**ADDENDUM NUMBER 1 ON INVITATION TO BID ITB20DB-123**

**TITLE: Institute of Black Culture & Institute of Hispanic-Latino Cultures Experiential Graphics**

## Vendor Questions for ITB20DB-123: Institute of Black Culture & Institute of Hispanic-Latino Cultures Experiential Graphics

Q35. Material call out "White Oak".

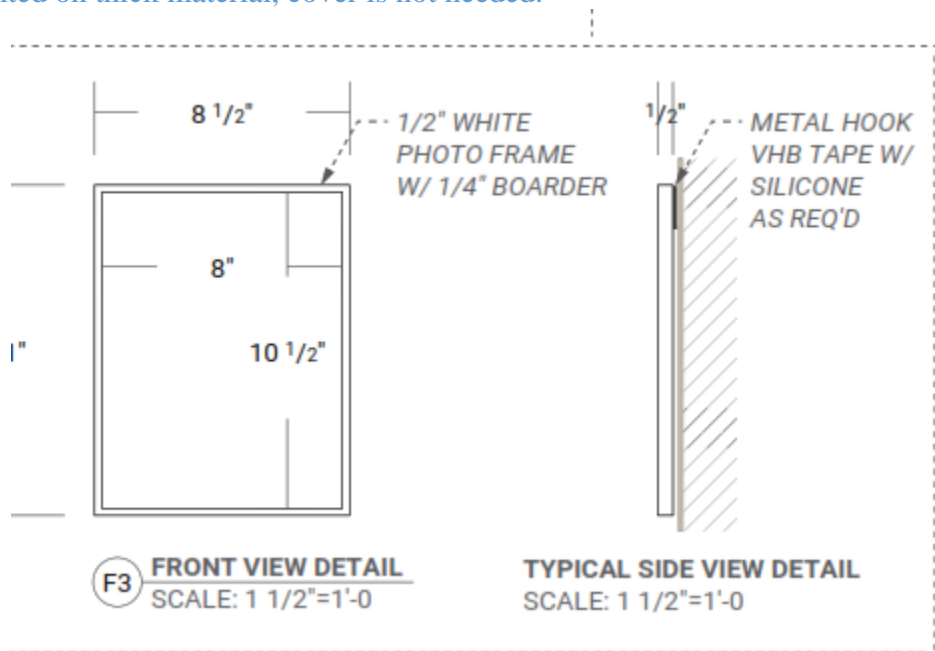
A35. A. Actual wood board for all sign types?

Yes.

B. Can a laminate panel on a painted acrylic qualify as a substitute for all sign types?  
Please provide pricing on both. We will need to see the sample to make final decision.

Q40. IHLC-1B, sheet 03.08

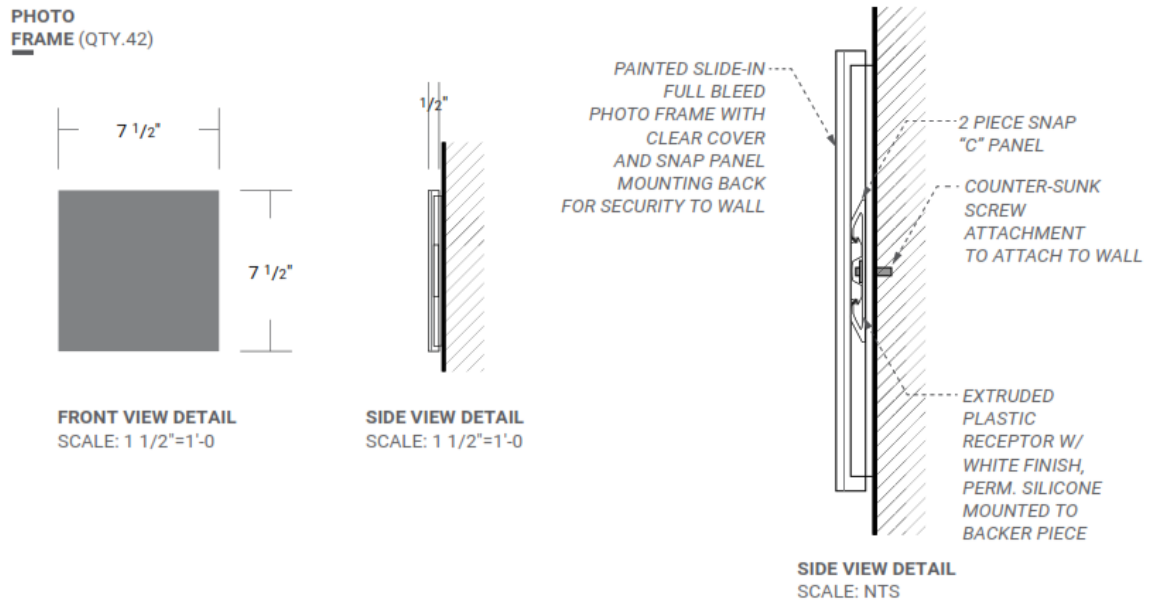
A40. A. PHOTO FRAME – is there a specific product the architect is considering.

There is no specific product we are considering. Please provide fabrication or product suggestions. We will need to see the product sample.
